NSRP #0349
May 1992

P-52 Balloting of Hull
and
Mechanical Standards

Panel SP-6

HEAVY DUTY DAVIT
TYPE II

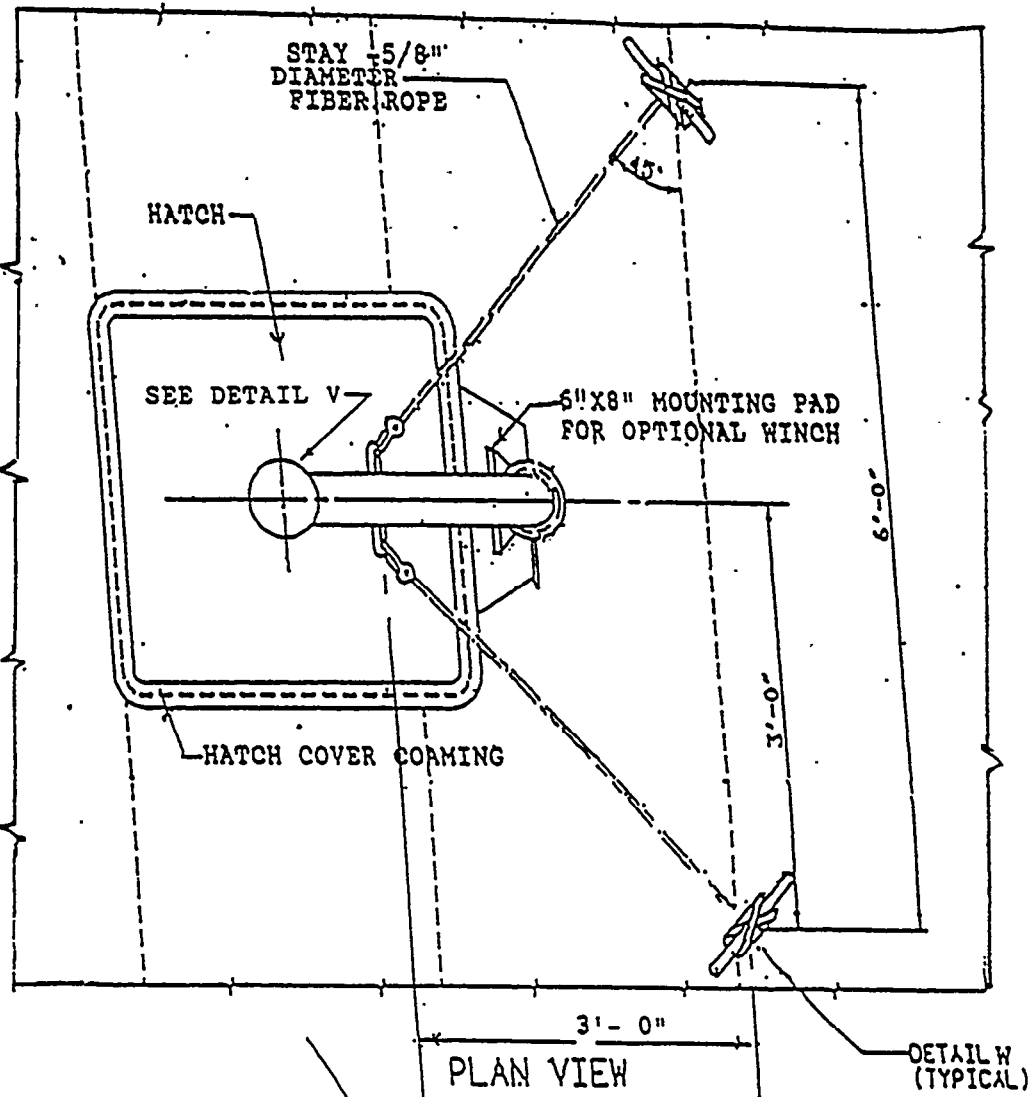
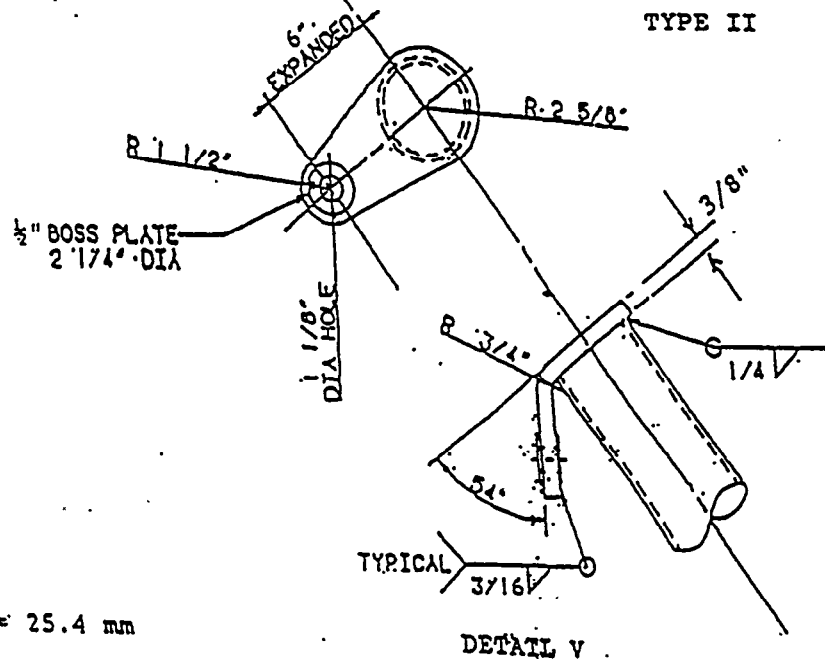
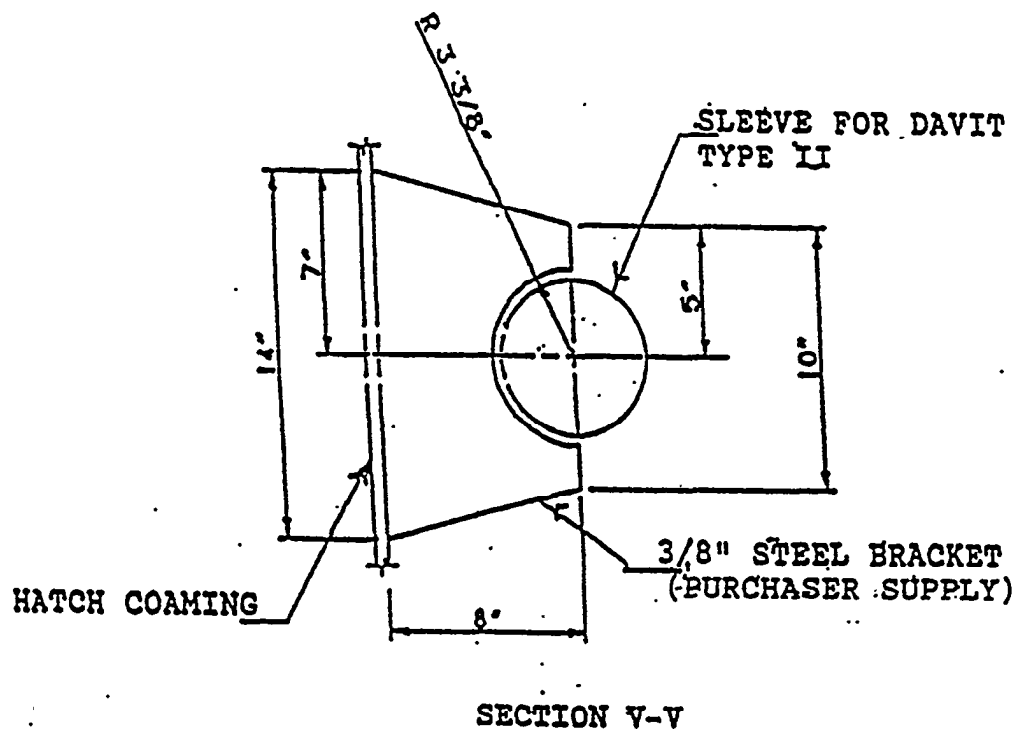
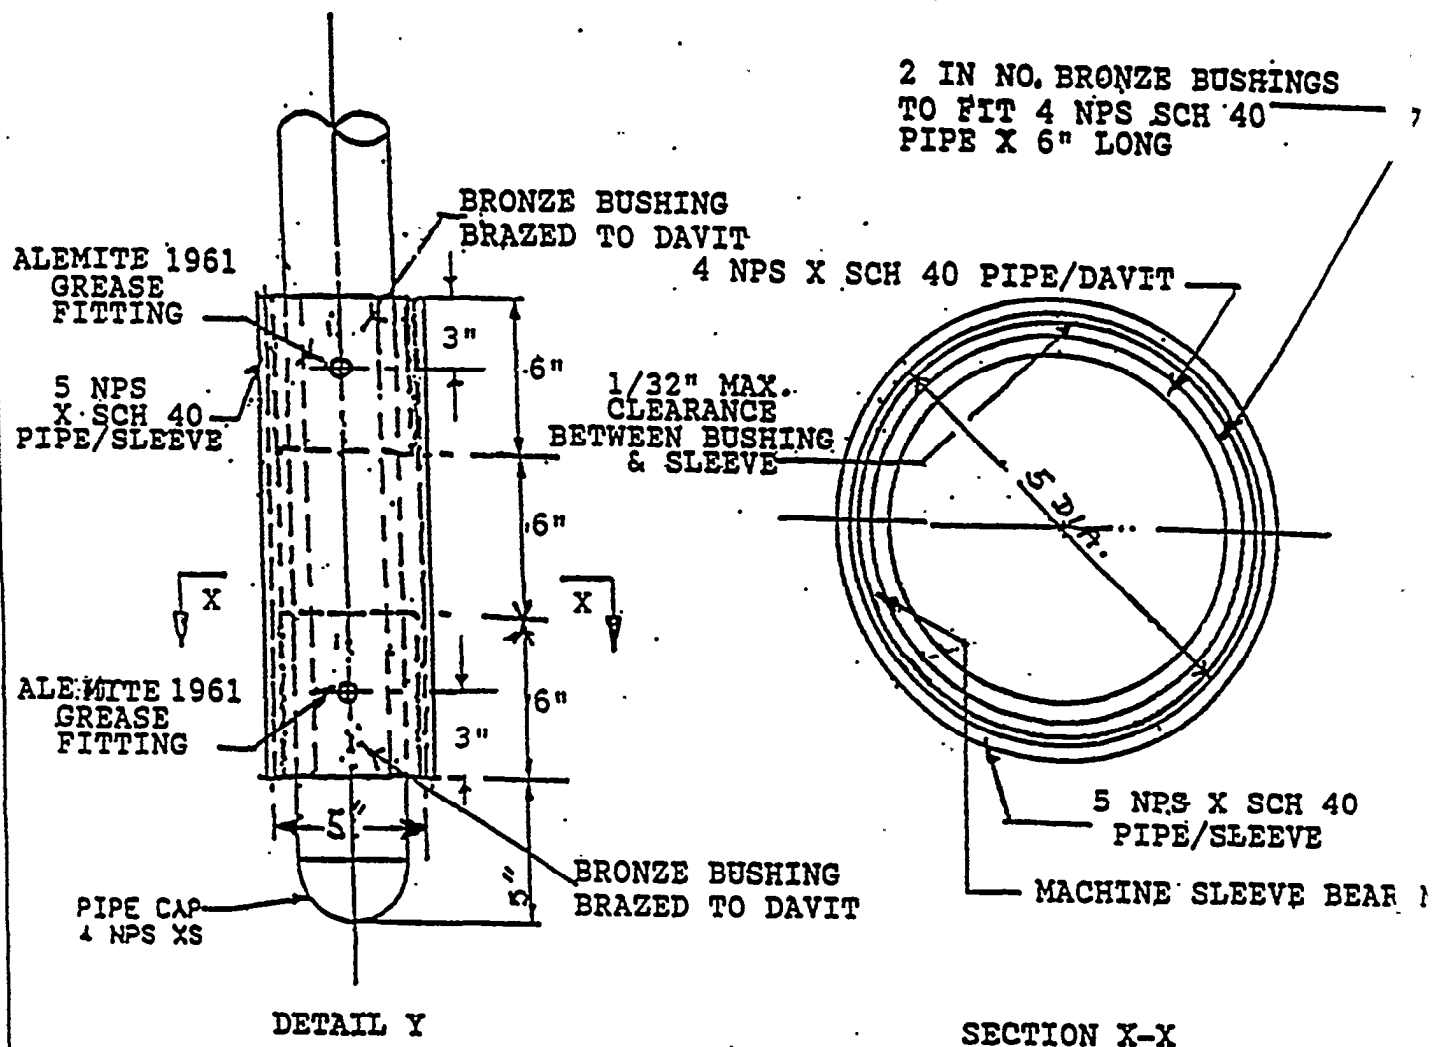
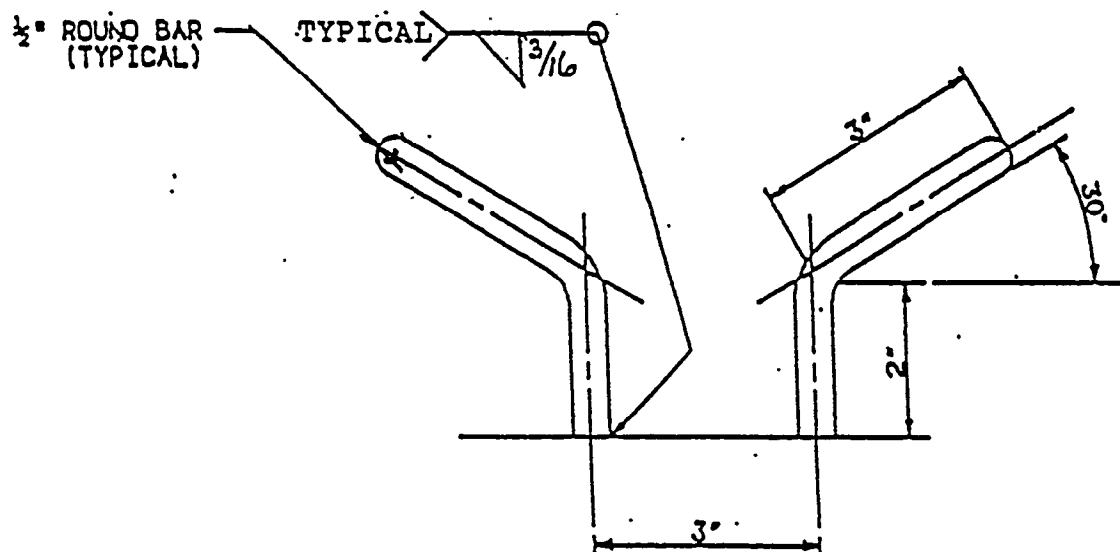
| 31. Fig. 2 - Indicate detail 'C' as cleat,. | Agree |
| 32. Fig. 2 - Indicate what support for detail B is. | Not Required; |
| 33. Fig. 2 - Indicate or detail base plate which davit rests on. | Disagree |

47. Fig. 2 - Comment (43) above applies to this figure.

48. Fig. 2 - Change 1/4" fillet weld to 1/8" to suit det. C.

| 21.. Fig.2 - Remove Det.. Y Cleats and use std. dk. cleats for securing . | These Cleats are part of manu- facturers supply; hence the sketch. |
| 22. Fig.2 - Dets X & Y are missing "typical" cm weld. | Concur - Revised |

FIGURE 2

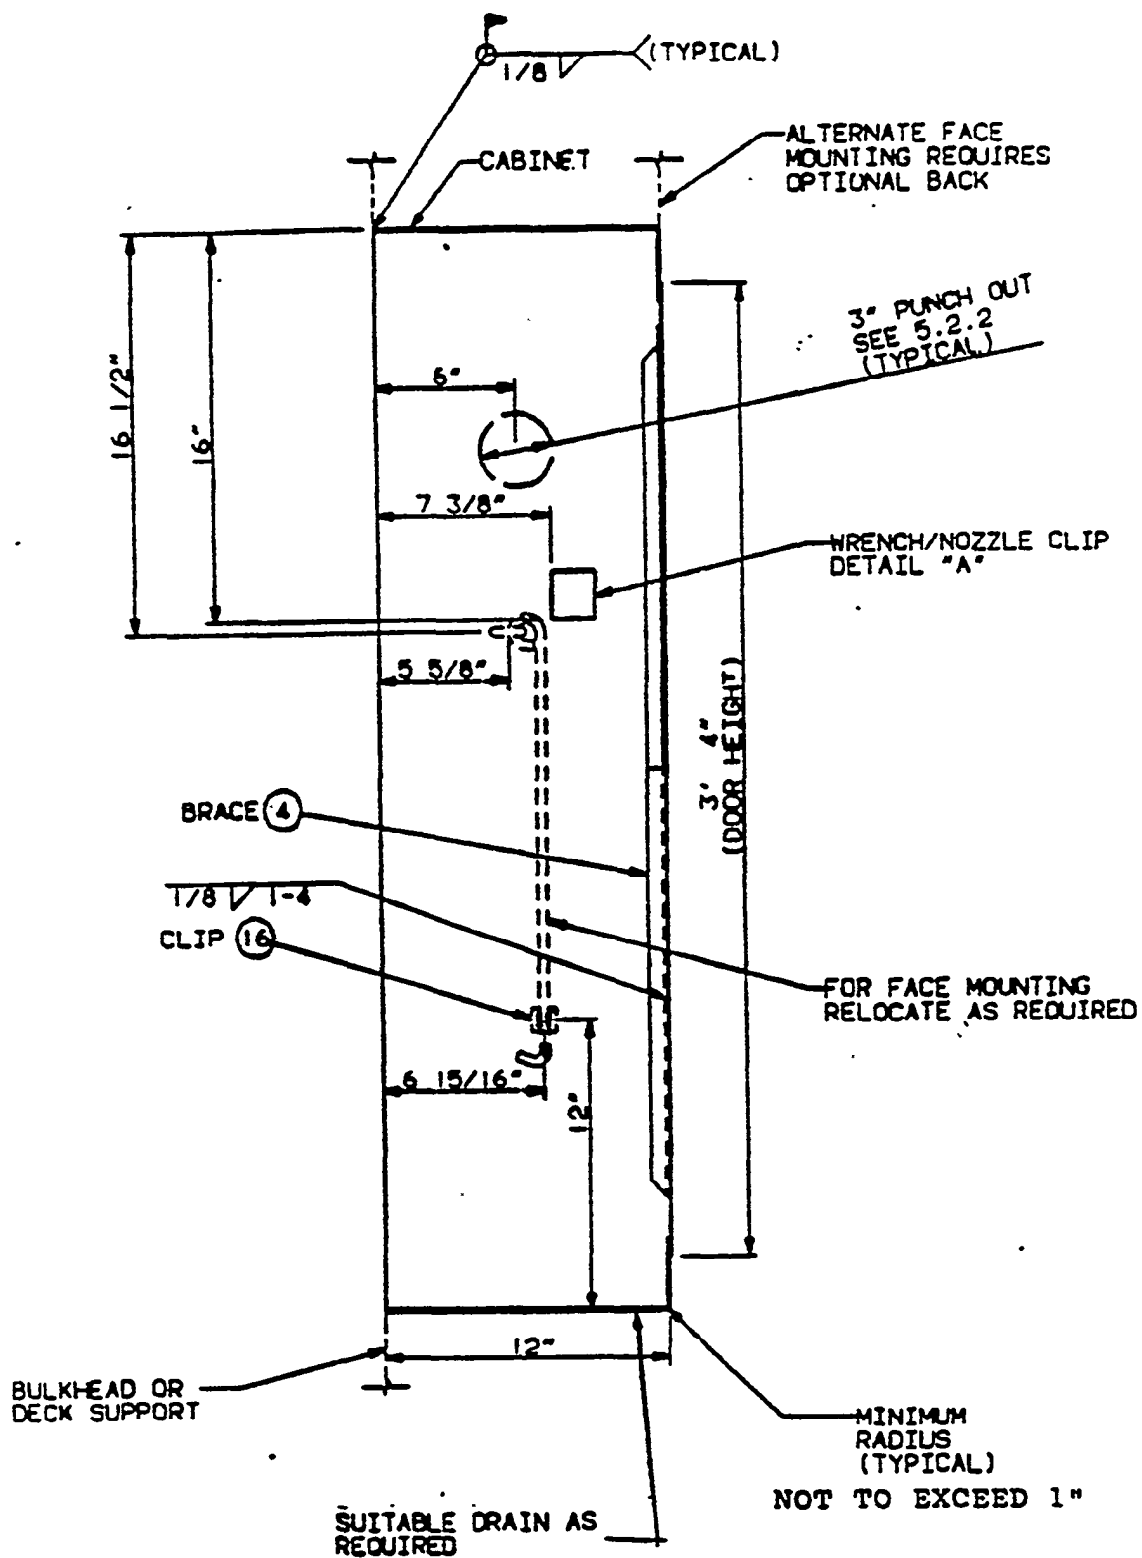
| 9. Page 9 - Section B-B- location for wrench not satisfactory. | Disagree - See Fig 5 detail "A" for arrgt. |

FIGURE 1

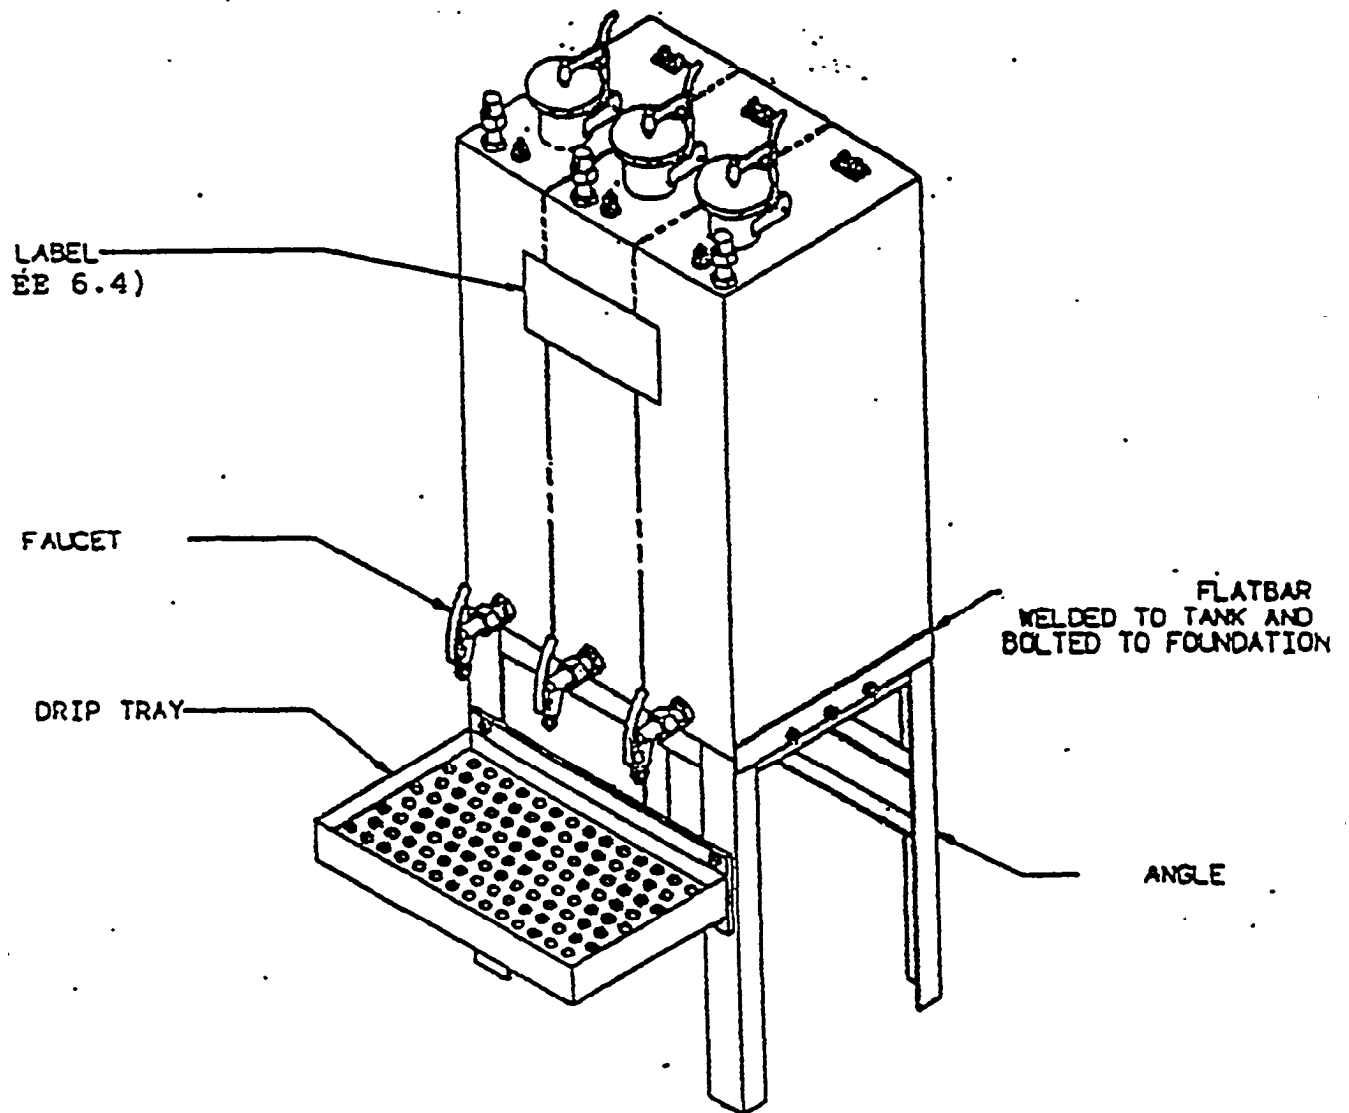
| 11. Fig. 1 - Next to either top or bottom "A" (Detail A-A) insert (See Figure 2)..... | Concur |

FIGURE . 2

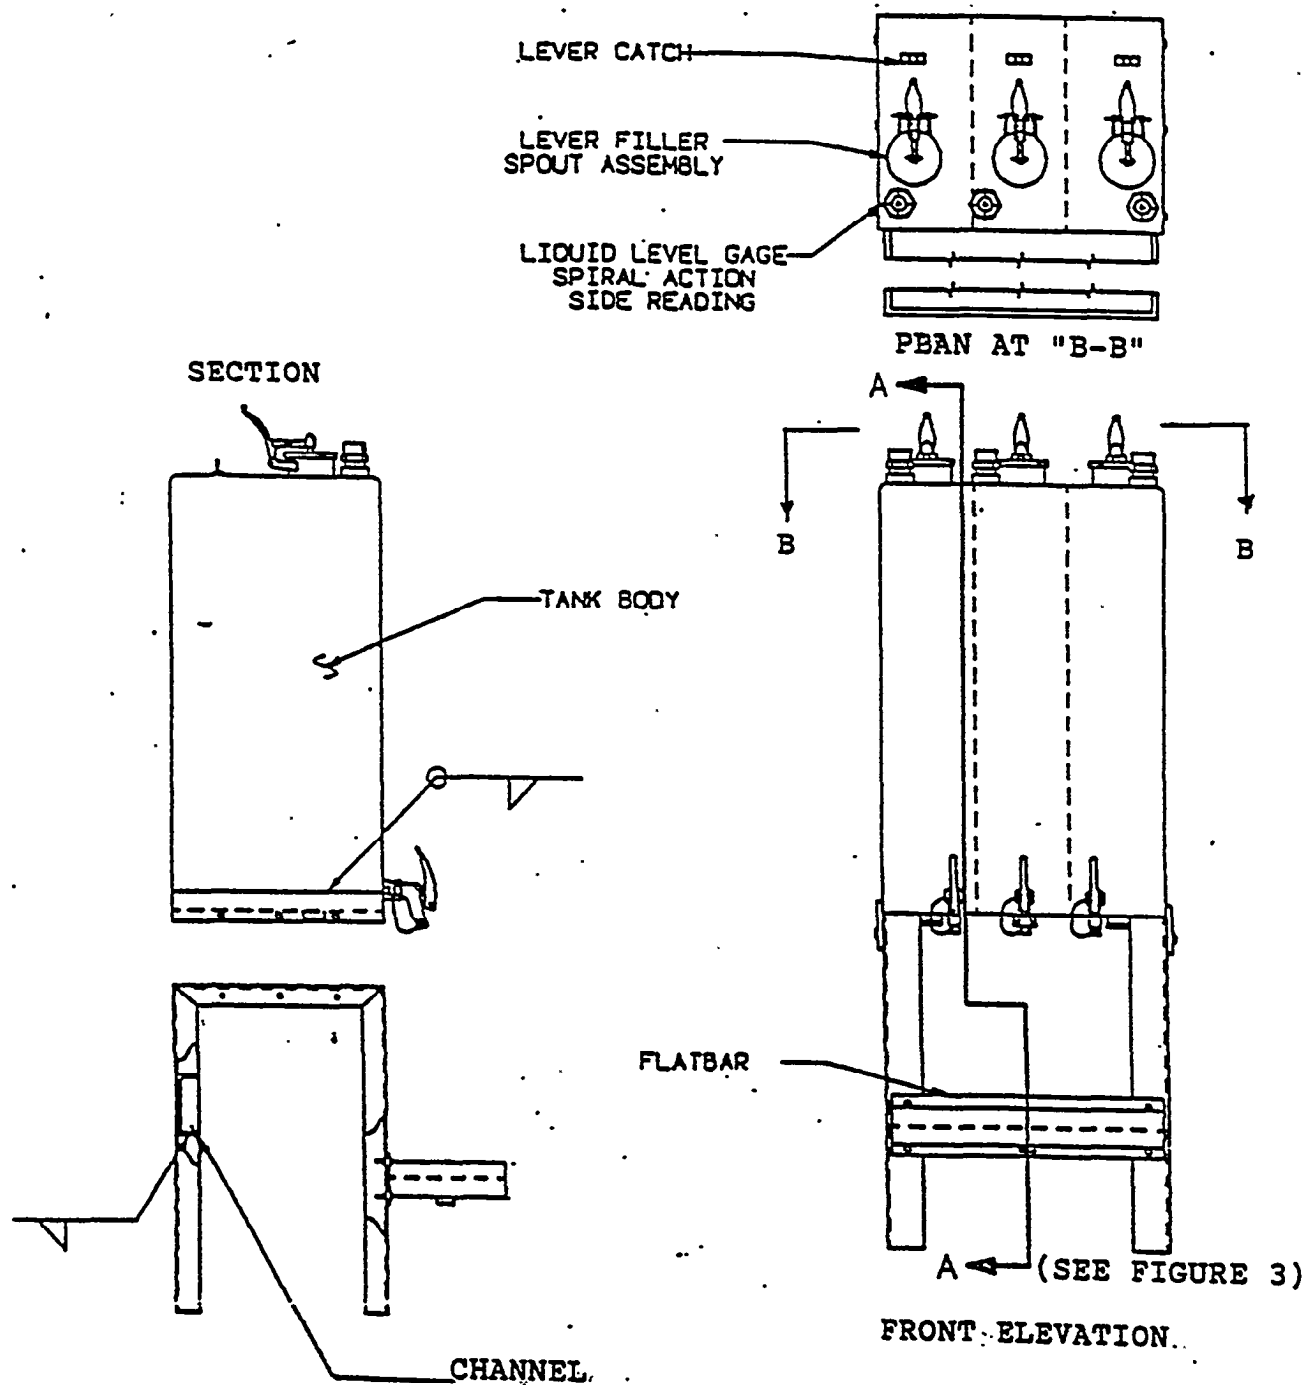
| 12. Fig. 2 - If "A-A" Section is the title of this Figure Insert.. | Non-Concur - Figure No.'s have been changed and comment (10) has been adhered to. |
